## **Access Compliance Report Public Rights-of-Way** (Curb Ramps)

Intersection ID: 10036700 Main Street: S CHURCH ST **Cross Street: N/A** Location: Ν **ADA ID: EAABE9CB177B** Ramp Type: BlendTrans1 Initial Pass/Fail: Pass **Overall Compliance: No Severity Score:** 2.75

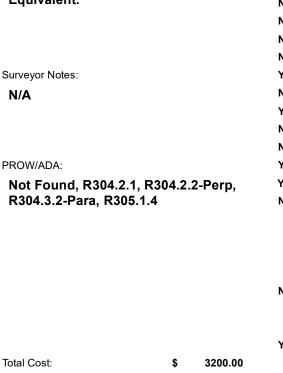
**Codes/Mitigation Info/Possible Solution** Possible Solutions: Remove & Replace Curb Ramp With **Two New Directional Ramps or** Equivalent. Surveyor Notes: N/A PROW/ADA: Not Found, R304.2.1, R304.2.2-Perp, R304.3.2-Para, R305.1.4

X Walk 1 X Slope (%)	5.4		X Walk 2 X Slope (%)	0.5
N/A	Ramp inside XWalk1?	N/A	N/A	Ramp inside XWalk2?	N/A
	Road Slope (%)	4.7		Clear Space?	Yes
	Road X Slope (%)	4.6	N/A	Clear Space to XWalk (in)	N/A
Yes	Any Obstructions?	No	Yes	Storm Grate/Utility Hazard?	No
	Obstruction Type			Storm Grate/Utility Type	
		N/A			N/A
			Yes	Surface Condition? (G/P)	Good
			No	Curb Slope (%)	7.0
